**ADDENDUM NO. 1**  
**May 21, 2026**  
**230693**

RE: **Charter Oaks Village Cooperative**  
**Arundel, ME**  
**Phase 1 Distribution Improvements**

FROM: DuBOIS & KING, INC.  
208 Union Avenue  
Laconia, NH 03246

SHEET NUMBER:  
**C6**

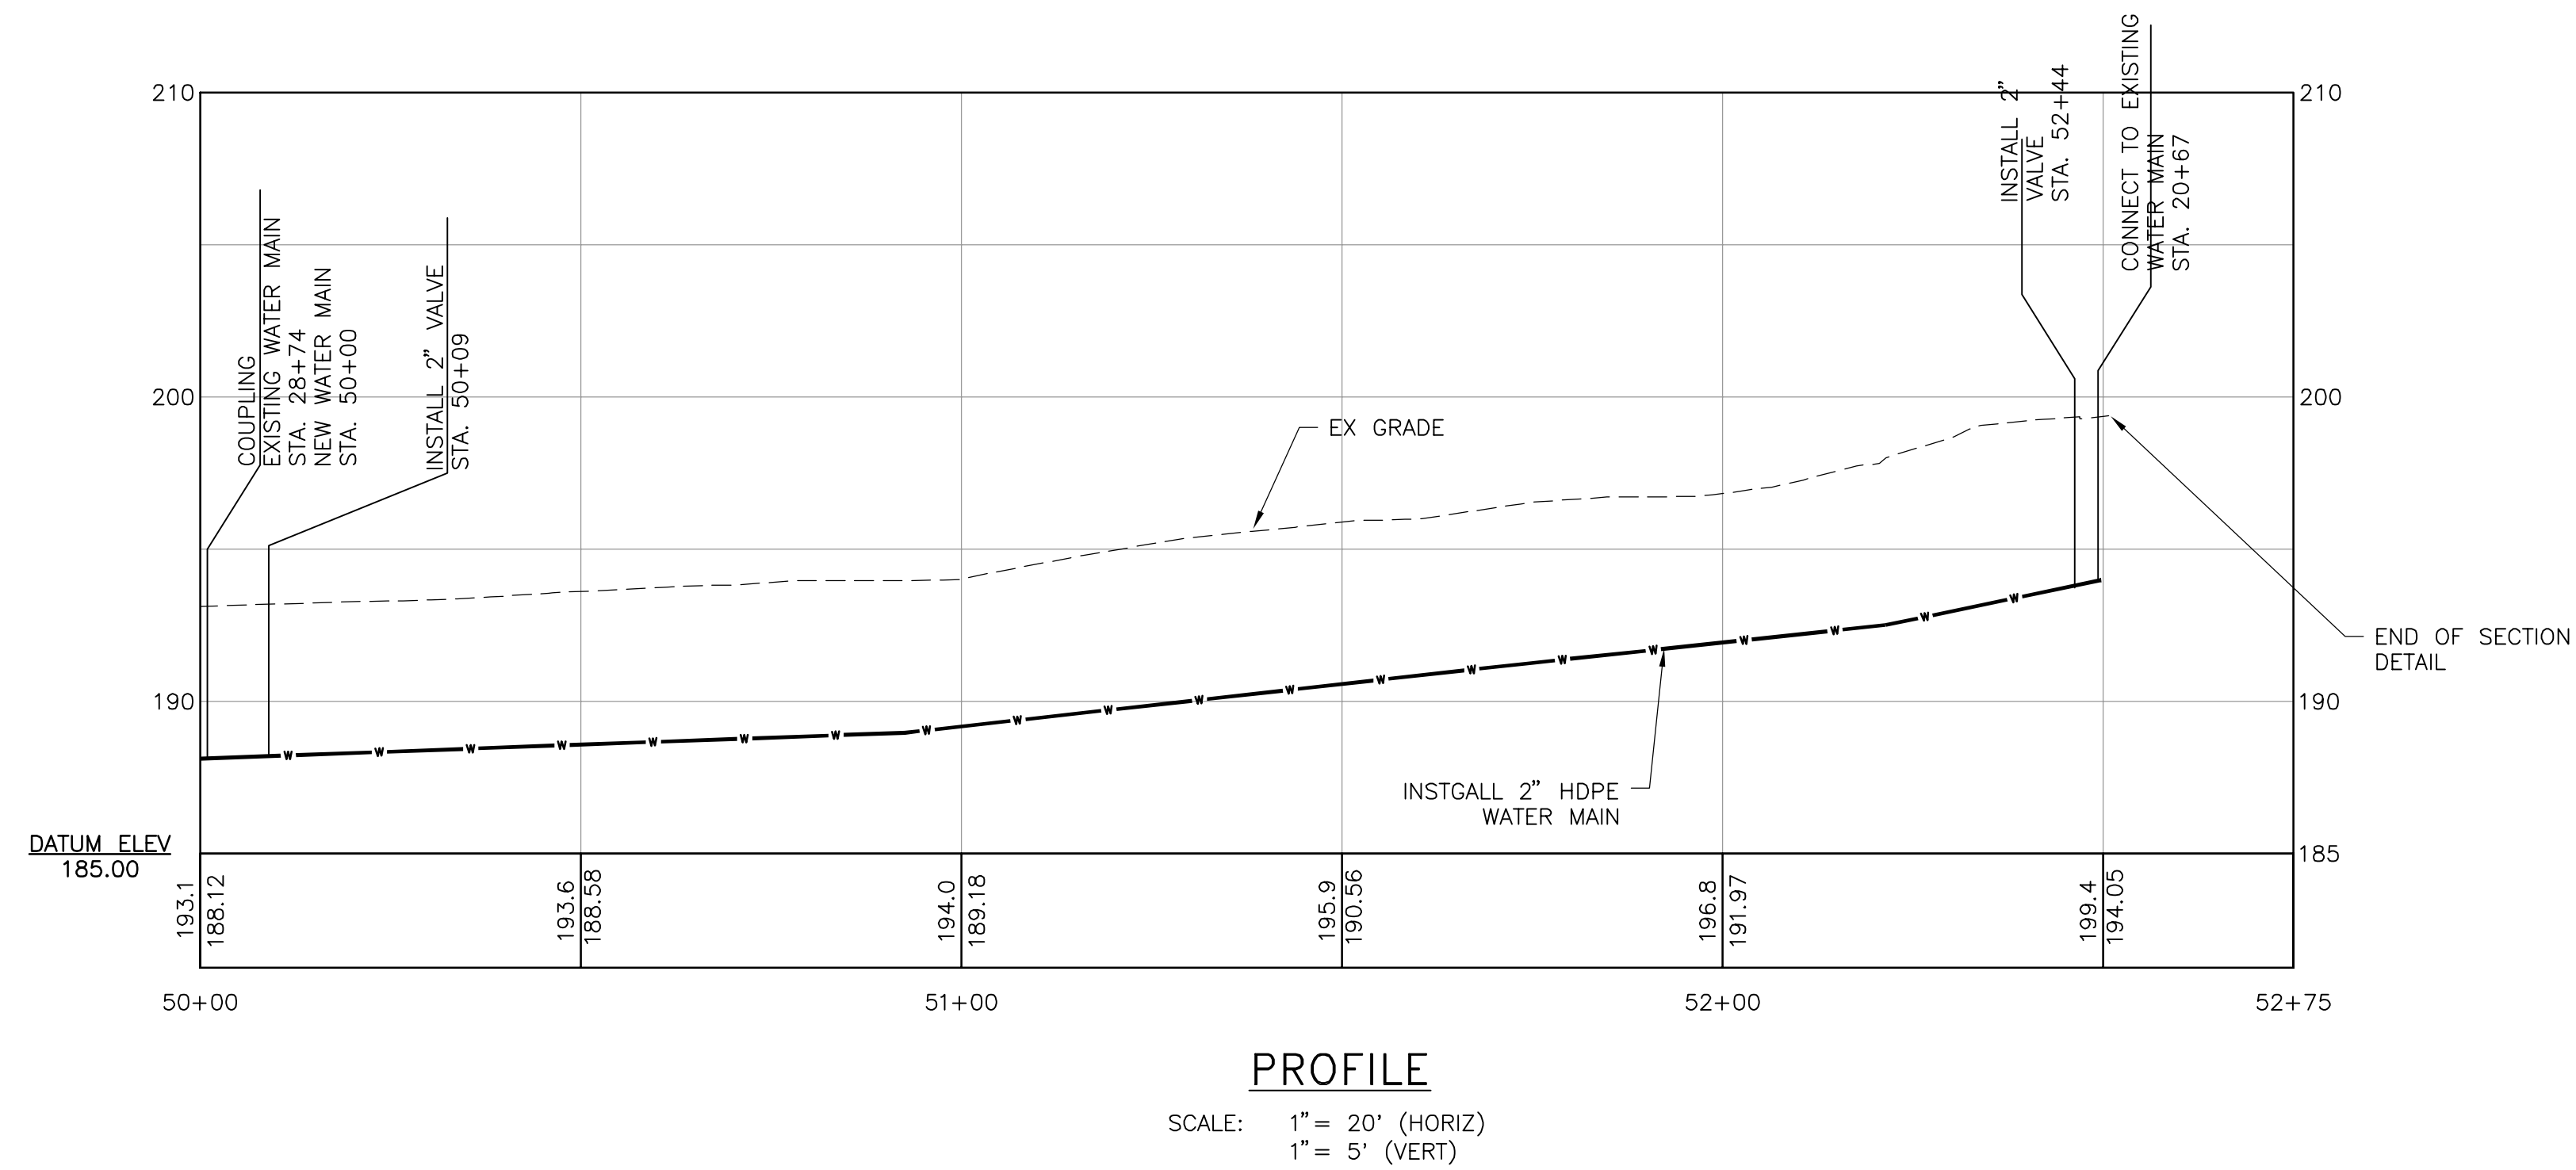
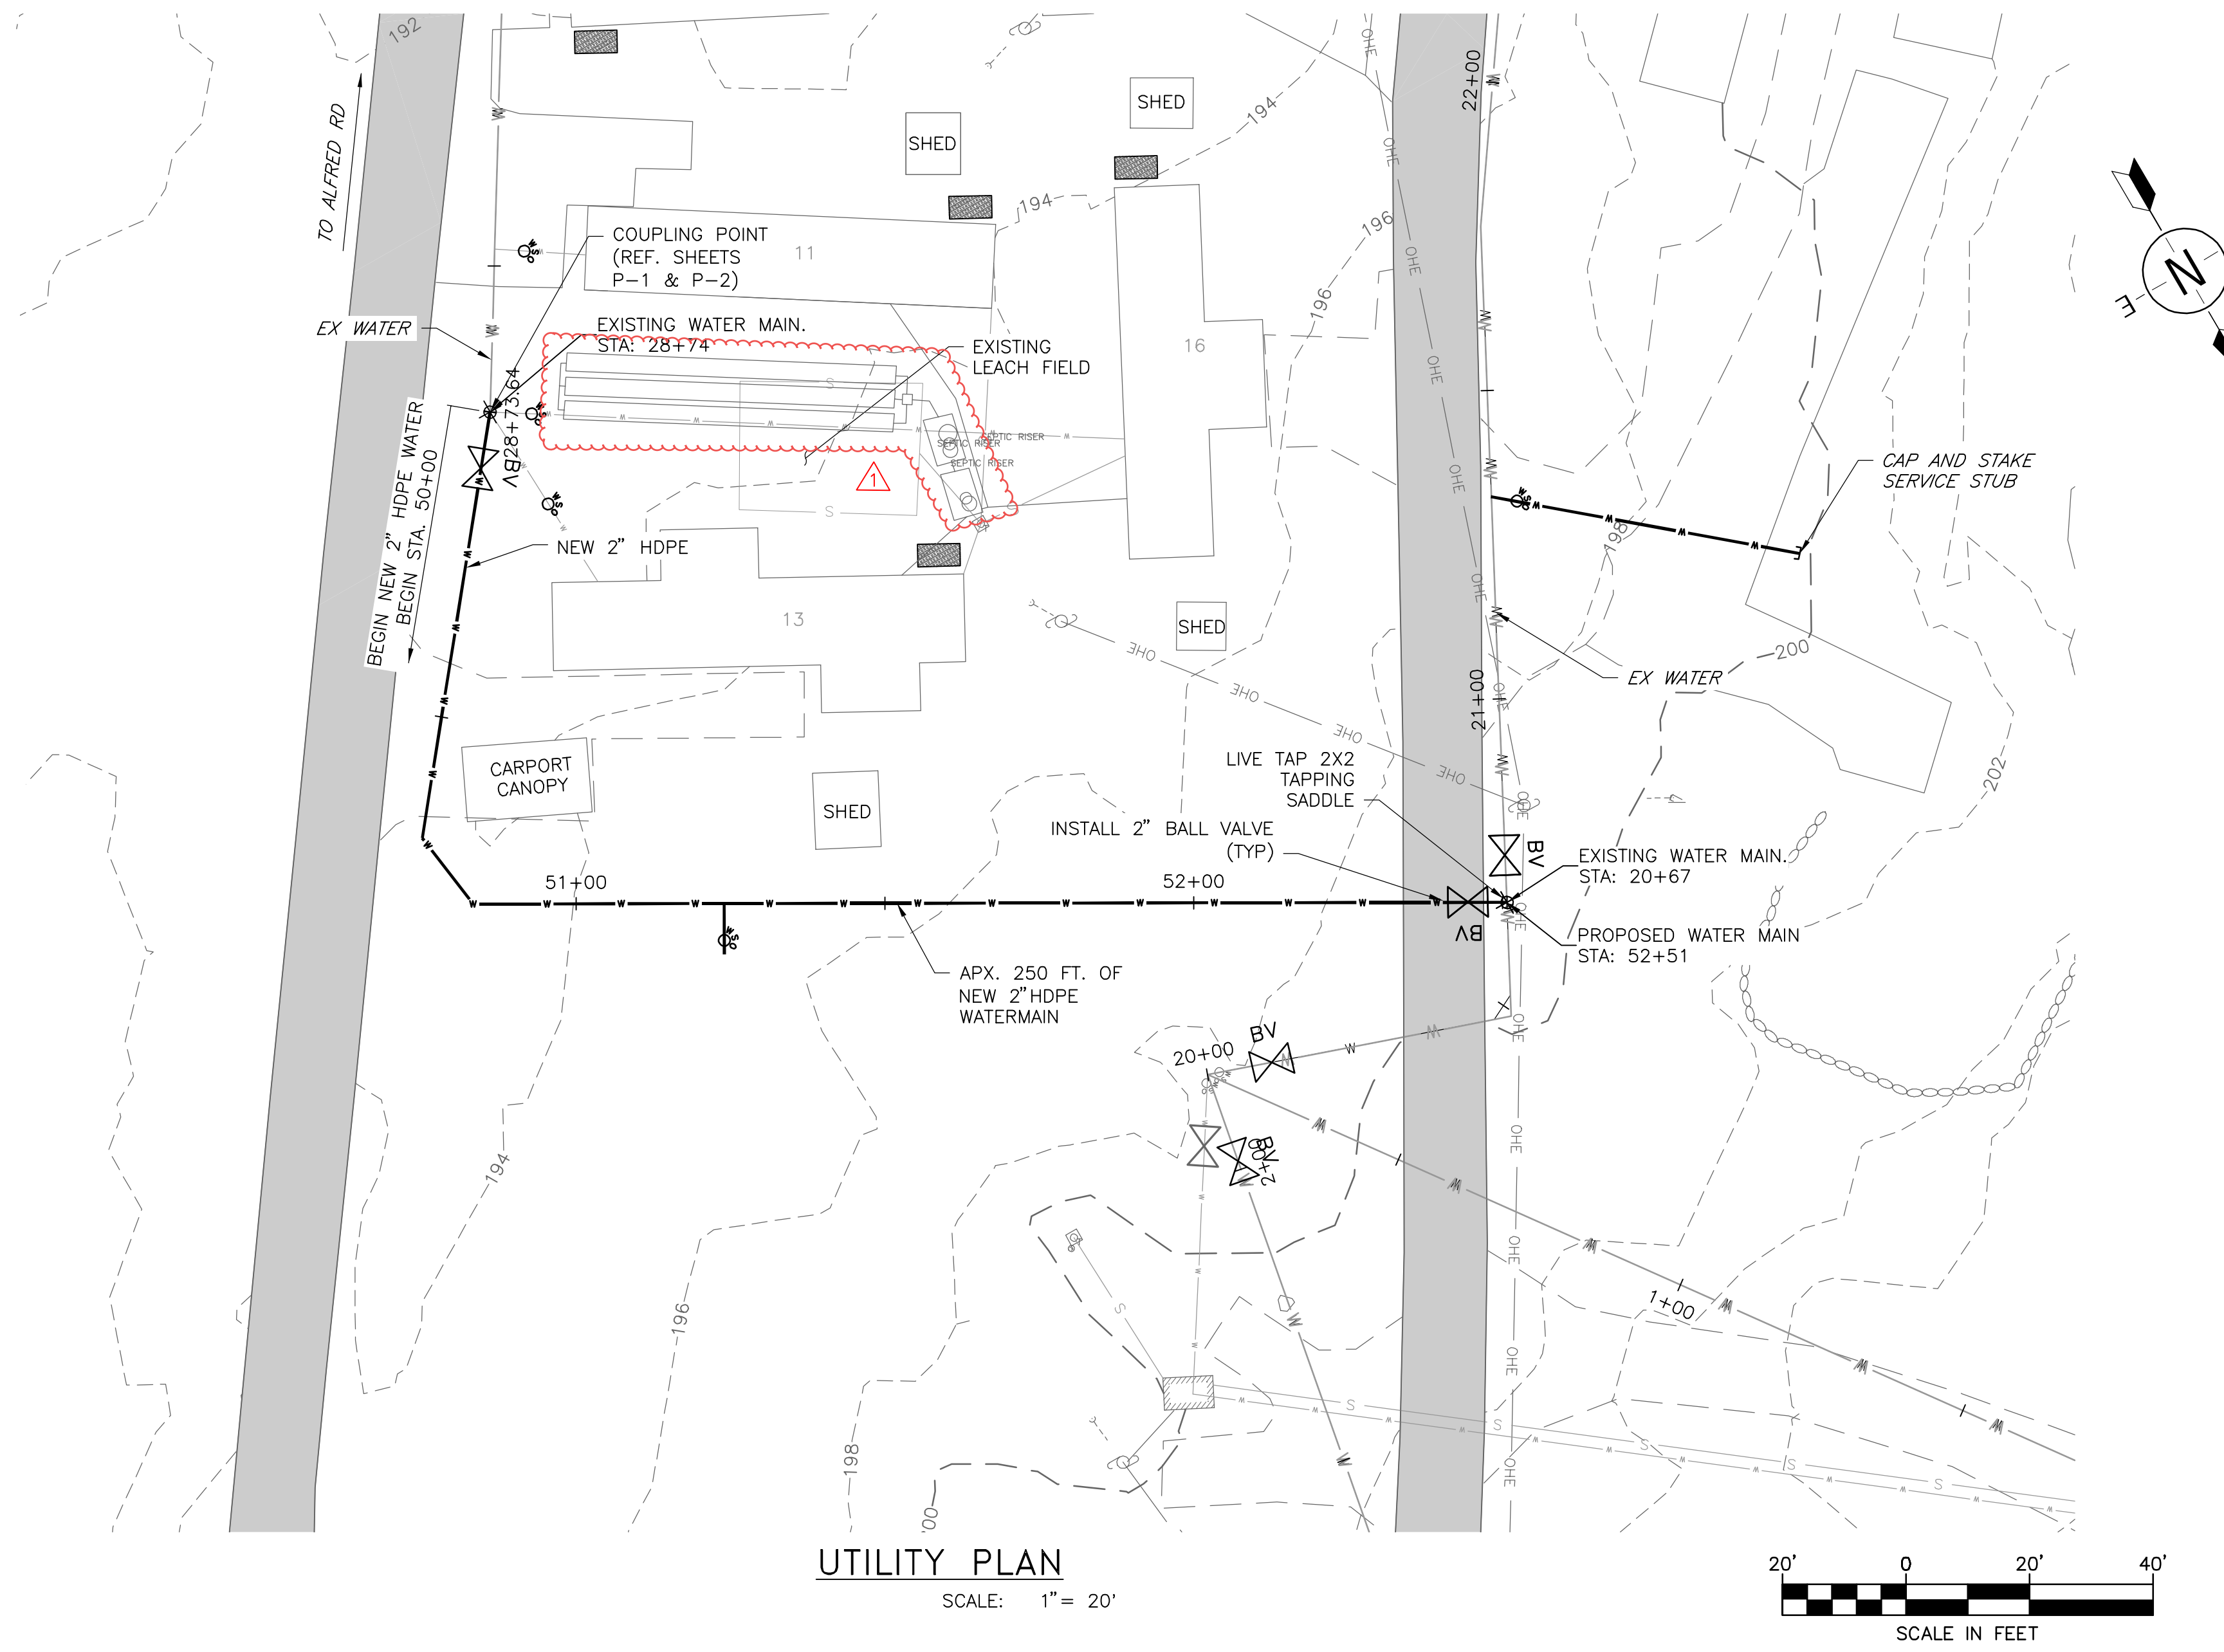
- New individual services were reconfigured to make it clear that no work is to be done under the home. (Sheet C2)
- A recently replaced septic system was added to the drawings as it is near a test pitting location and a connection point for the water main extension. (Sheets C3, C6)
- AST details were added to the plan set. (Sheet C10)

| REVISIONS | REVISION DESCRIPTION       | DATE    | NUMBER | BY  |
|-----------|----------------------------|---------|--------|-----|
| 1         | ADD SEPTIC SYSTEM LOCATION | 5/11/26 | 1      | SAW |
